Millstone Nuclear Power Station, Unit 3
NRC Chemical Engineering Branch (Fire Protection)
Review Meeting, March 28, 1984

Status of the NRC-CMEB (Fire Protection)
Draft SER Open Items Discussed at the Meeting
with the NRC-CMEB March 28, 1984

Responses to the Draft SER Open Items

SEE SKETCH 'D'

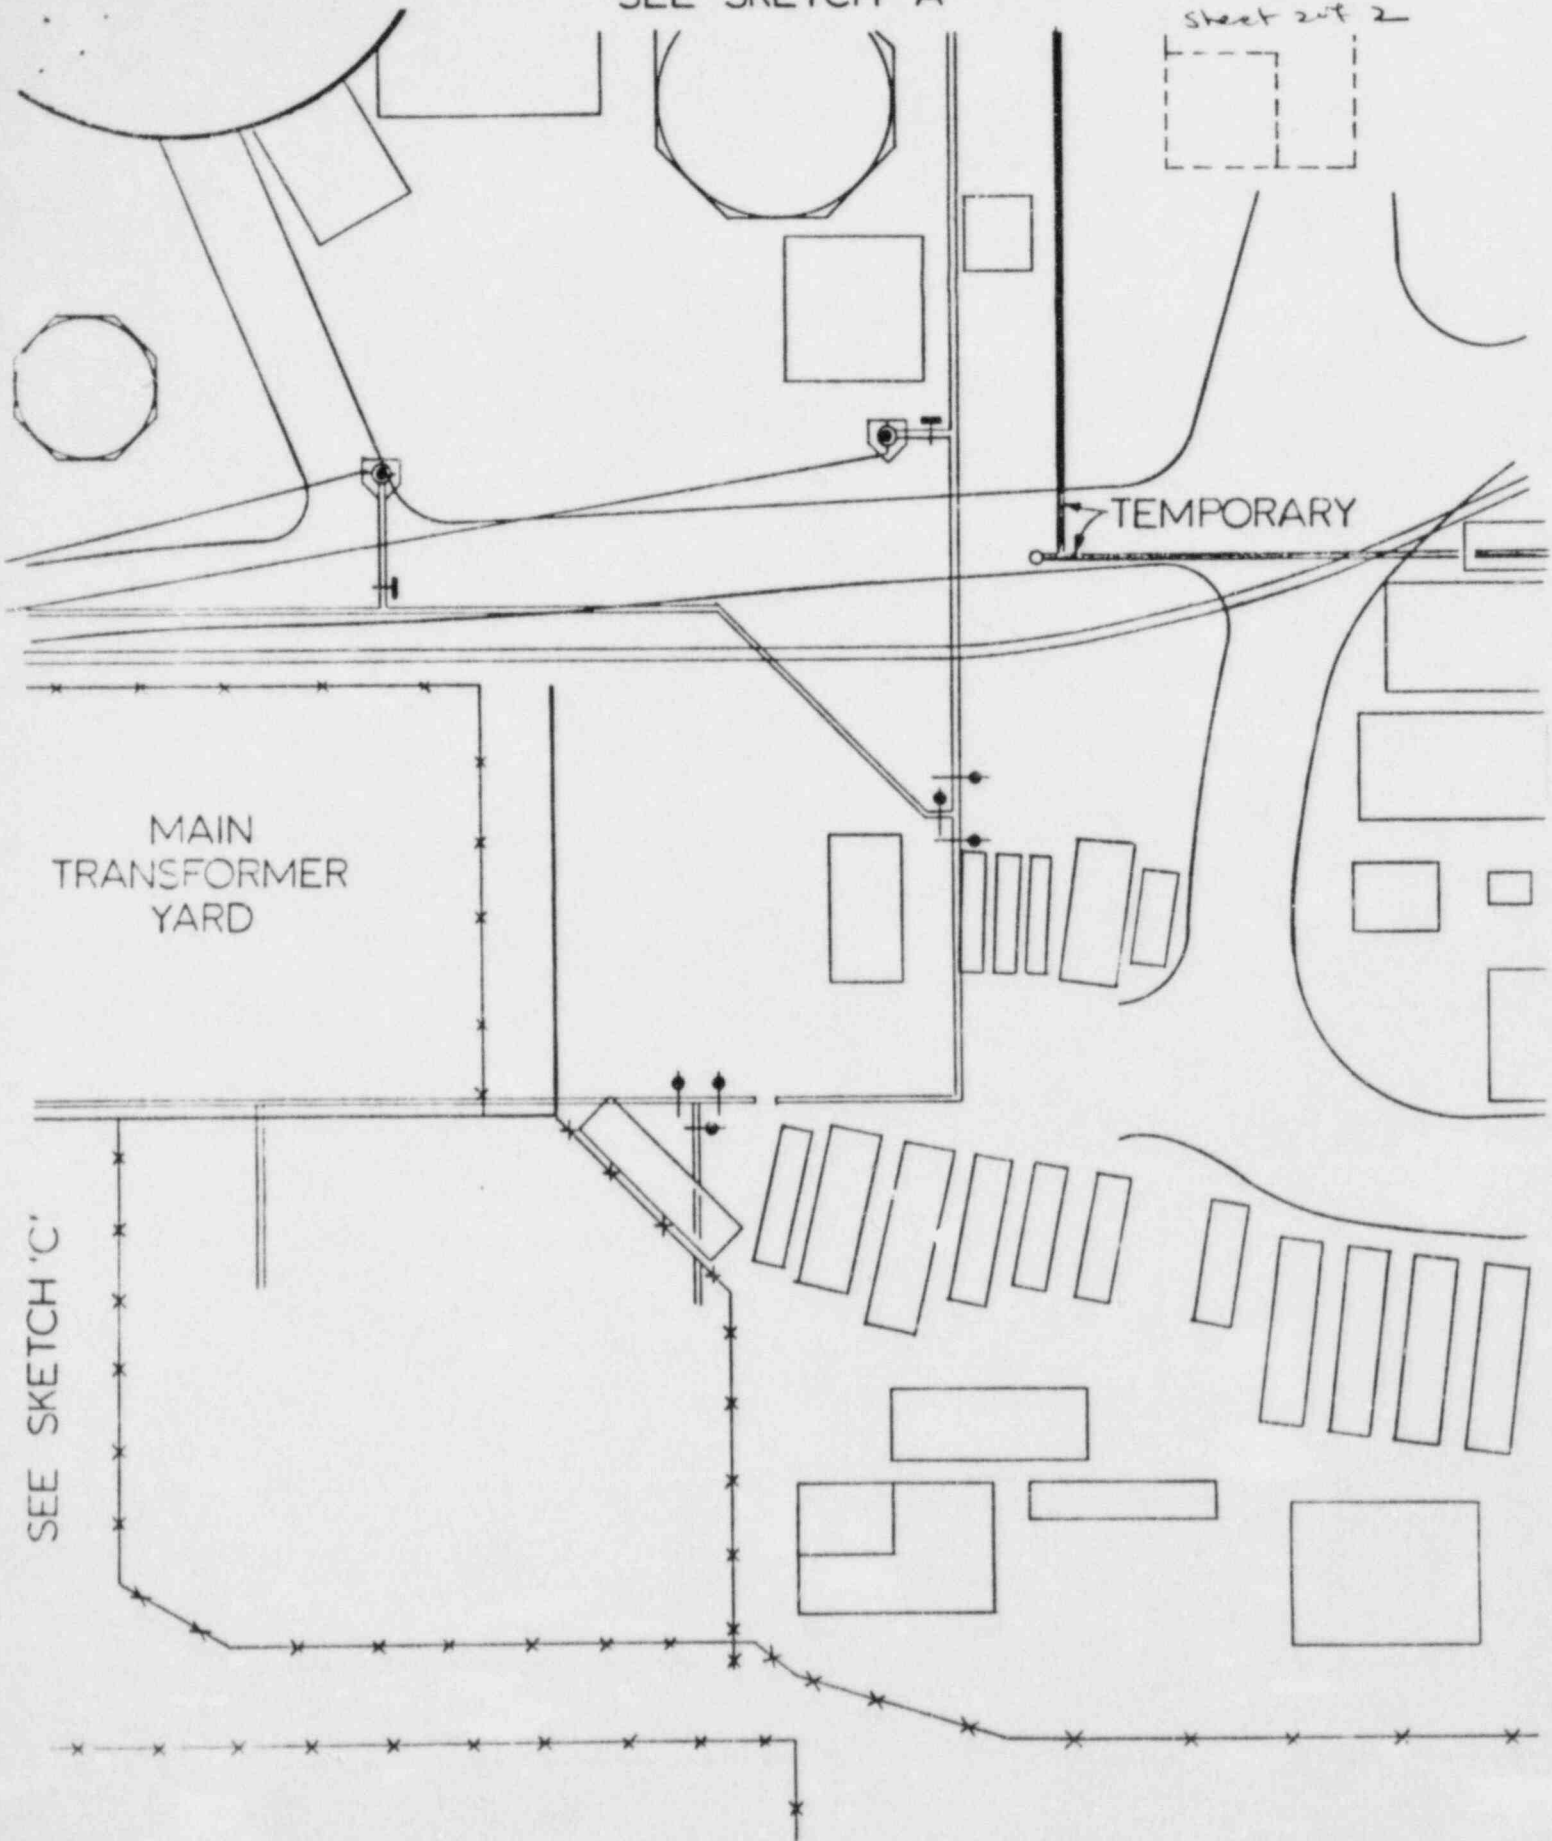
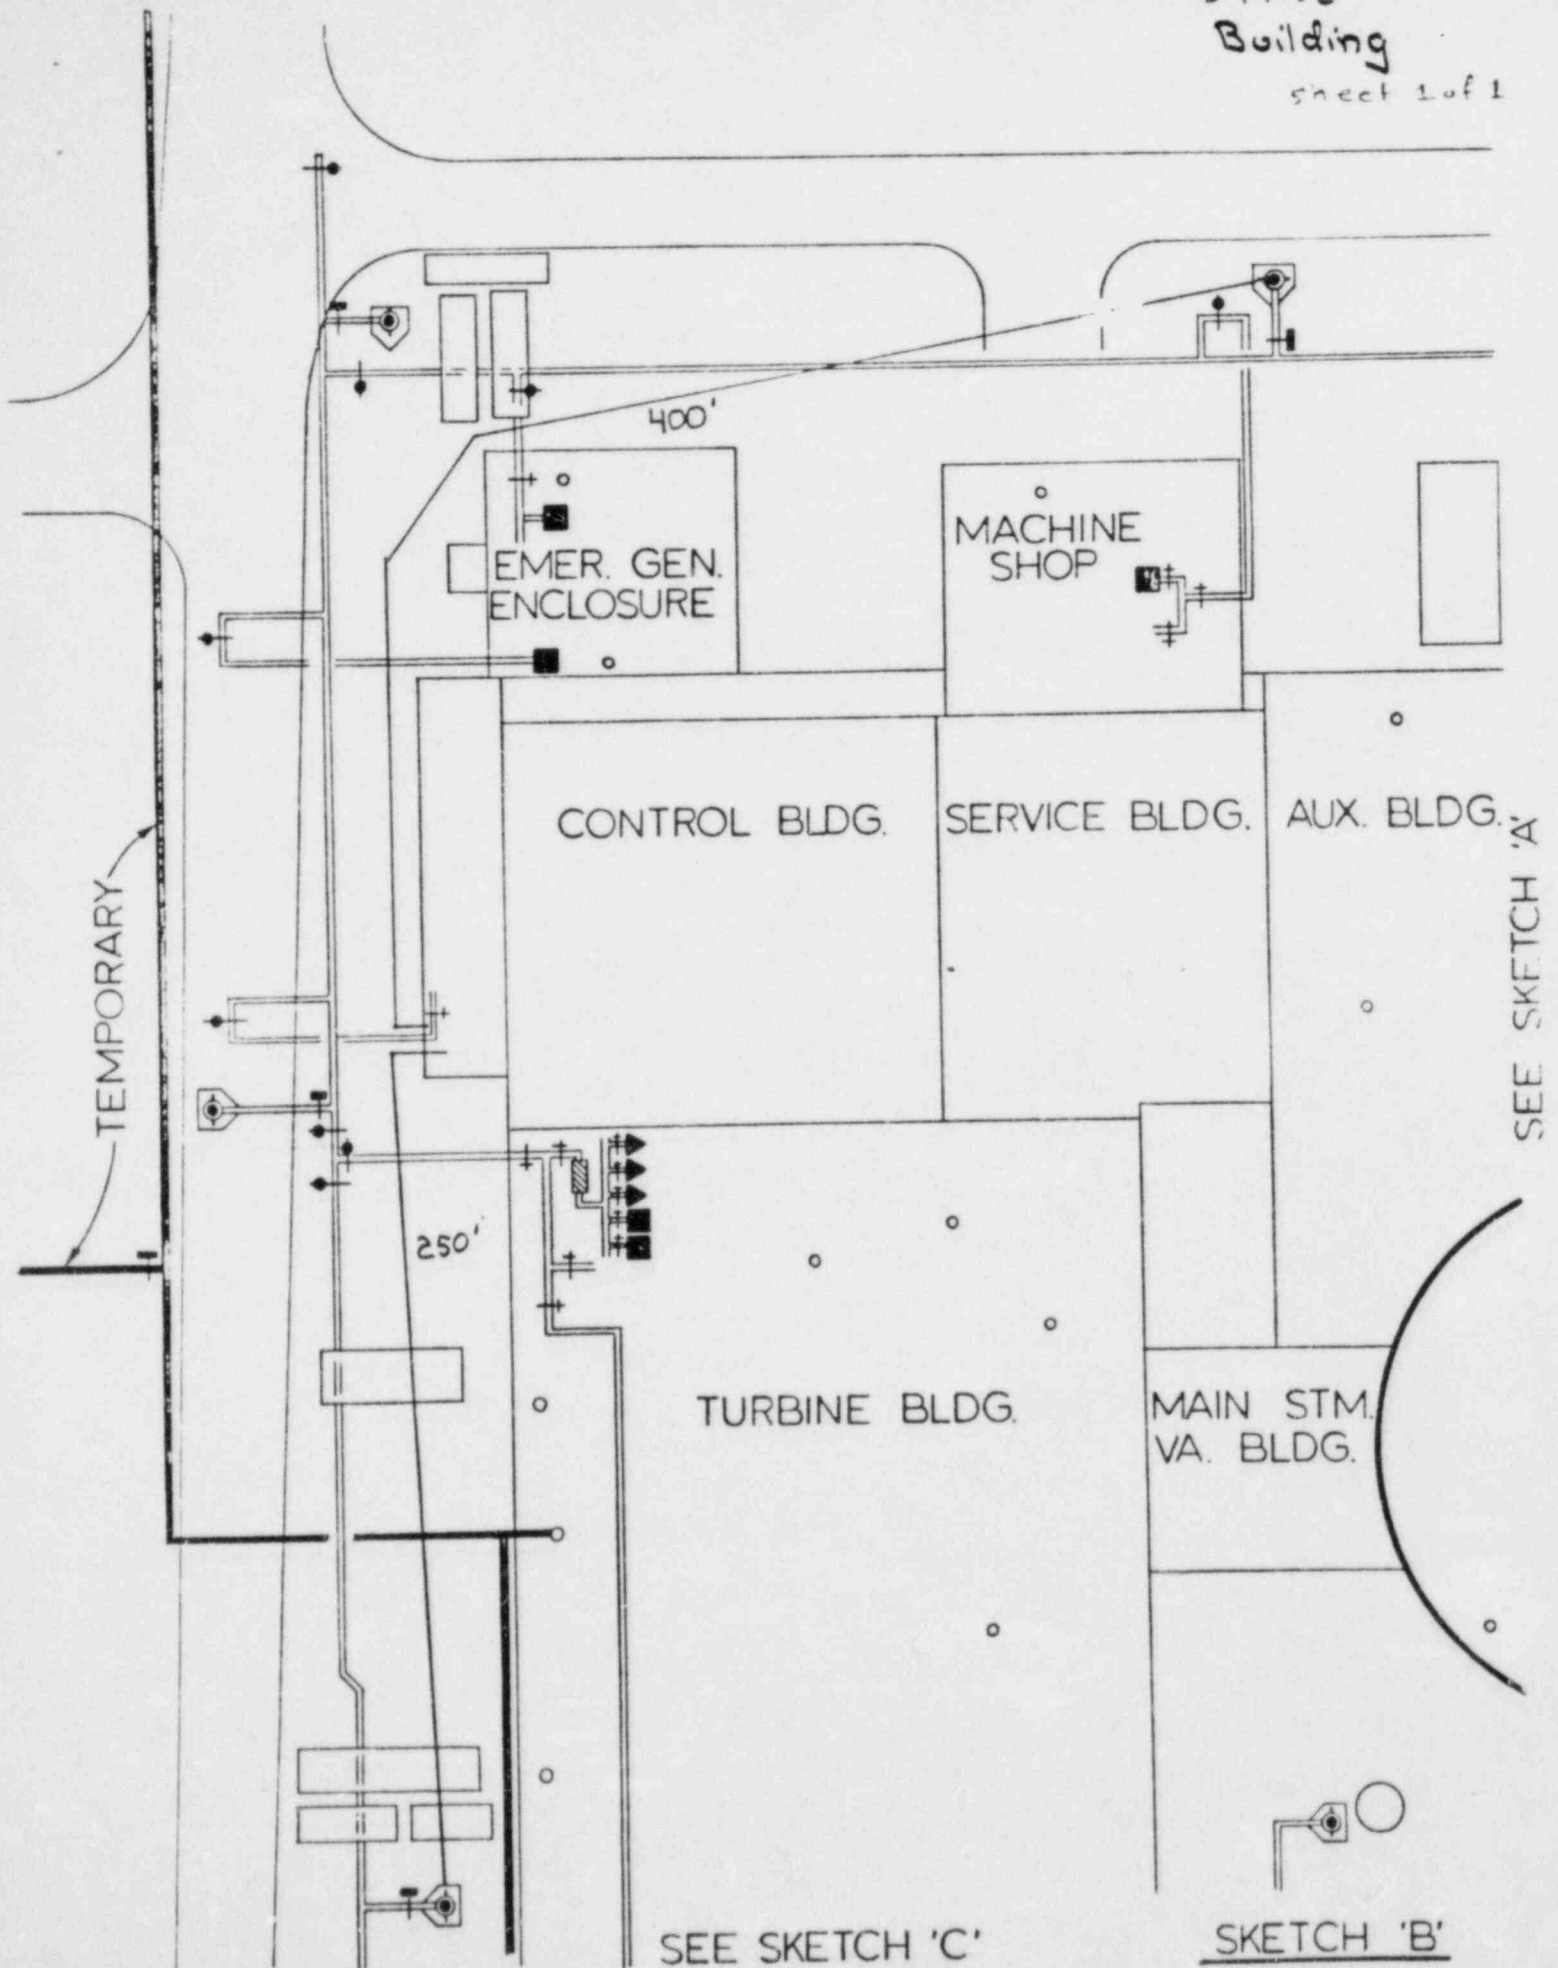
We will require the applicant to provide a fire protection water supply for the emergency generator enclosure, service building, waste disposal building, containment and the auxiliary boiler room such that a single break or failure in the supply piping will not result in the loss of both the primary and secondary water supplies. This is an open item.

The design of the underground fire water supply system at Millstone Unit No. 3, as illustrated on attached sketches A through D, is such that a minimum number of fire water suppression systems would be affected by a single break or failure. This same philosophy has also been utilized in the design of the plants interior fire water suppression systems. It is NNECO's concept should a break or failure occur in the fire water supply piping at Millstone Unit No. 3 to either:

- o Temporarily supply those fire water suppression systems rendered inoperable utilizing large diameter fire hose (2½ inch). Fire hose of sufficient quantity and size would be utilized to adequately supply the inoperable systems. These fire hoses would be supplied from fire hydrants connected to the underground fire water supply system that are unaffected by the break and/or failure. (See Table FP14-1).
- o Provide adequate manual fire suppression capability, in those areas affected by the pipe/break failure, by routing fire hoses from adjacent operable portions of the fire water system.

1. Those portions of the fire water supply piping highlighted in yellow are considered inoperable based upon a pipe break.
2. The primary temporary supply is the shortest route/discharge to an operable yard hydrant/water source.
3. The secondary temporary supply is the alternate source to the primary should it be unavailable.

MP-3 TURBINE BUILDING FLOW TEST

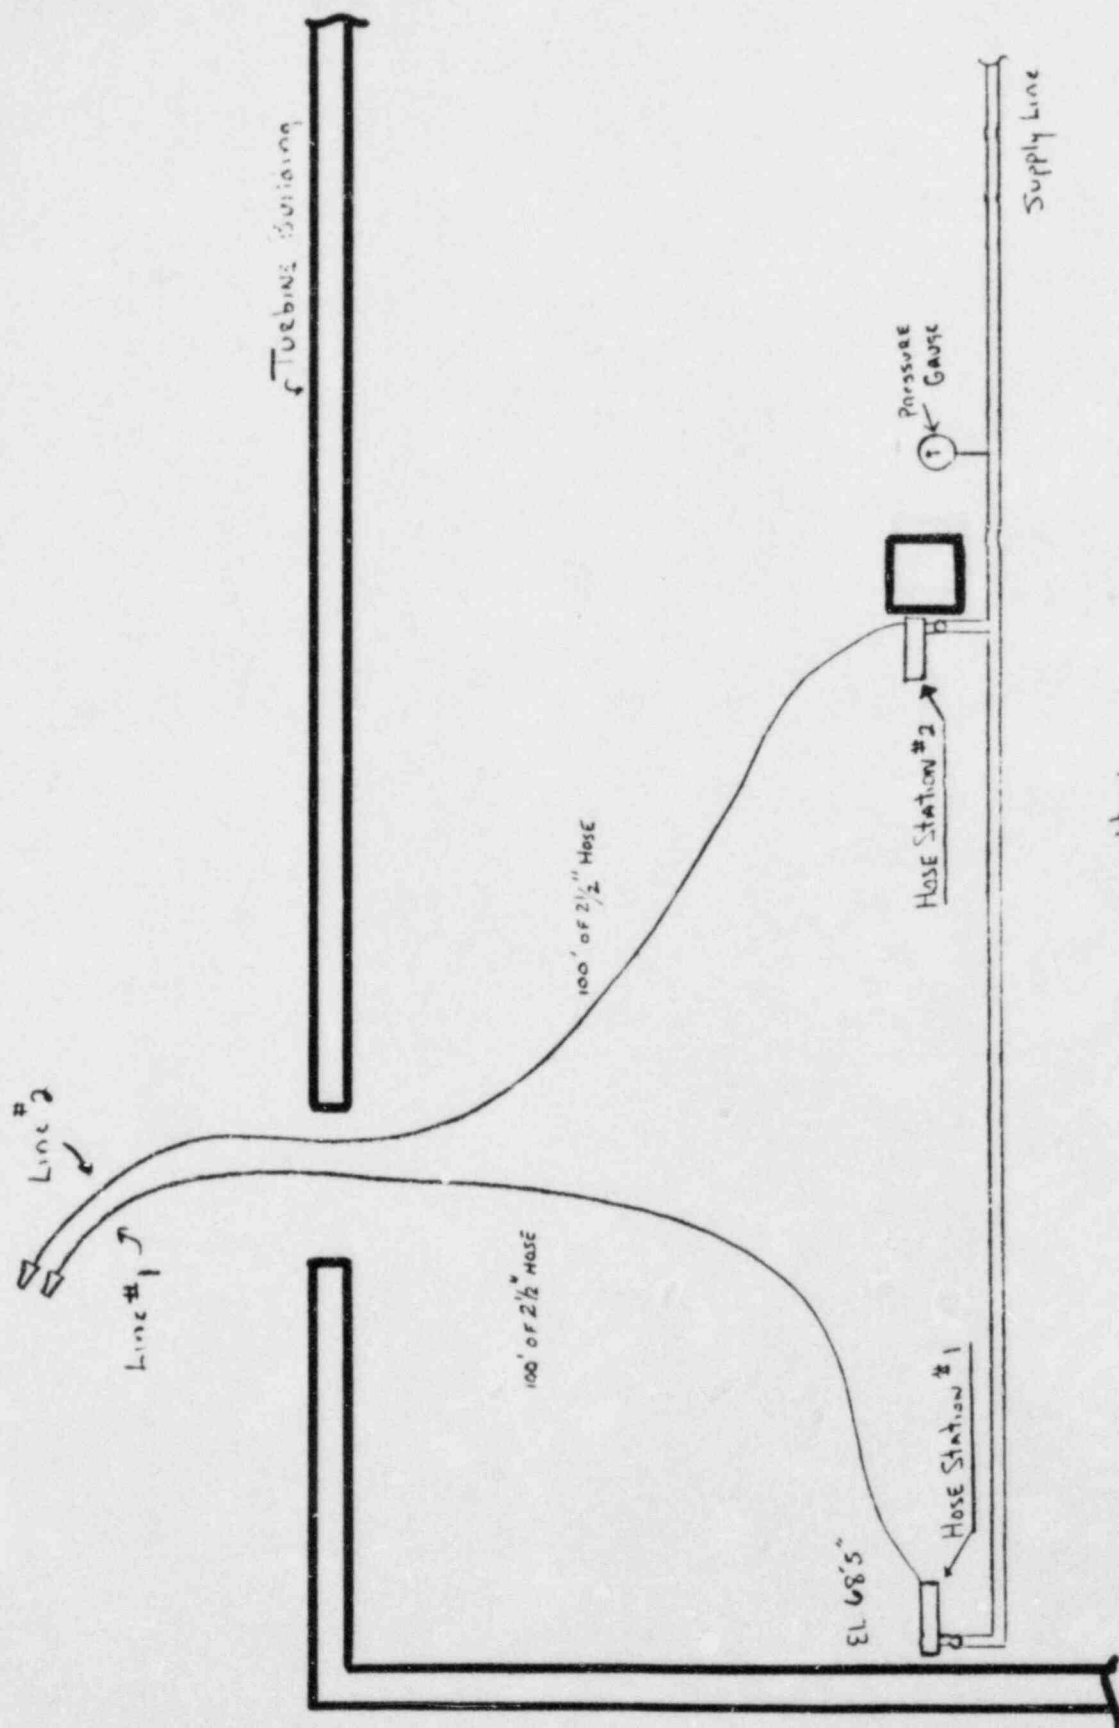
BTP CMEB 9.5-1, Section C.G.c, recommends standpipes to be sized four inches in diameter for multiple hose station supplies and two and one-half inches in diameter for single hose station supplies. The applicant has provided standpipe of a smaller size. We will require that applicant to either verify that the smaller sized standpipe is capable of providing the 500 gpm hose streams at adequate pressure for manual fire fighting operations, or increase the size of the piping in the standpipe system. This is an open item.

Additional information developed as a result of the NNECO/NRC March 7, 1984 meeting was presented at the March 28, 1984 Fire Protection Meeting (See Attachment FP17-1). During the meeting the NRC requested that NNECO verify that the fire protection system can provide the flow and pressures required in NFPA-14 for the standpipe of a smaller size than specified in BTP CMEB Section C.6.c considering the operation of two hose stations simultaneously with the largest water demand from suppression system in the vicinity of the hose stations. The Attachment FP17-2 provides the above requested information.
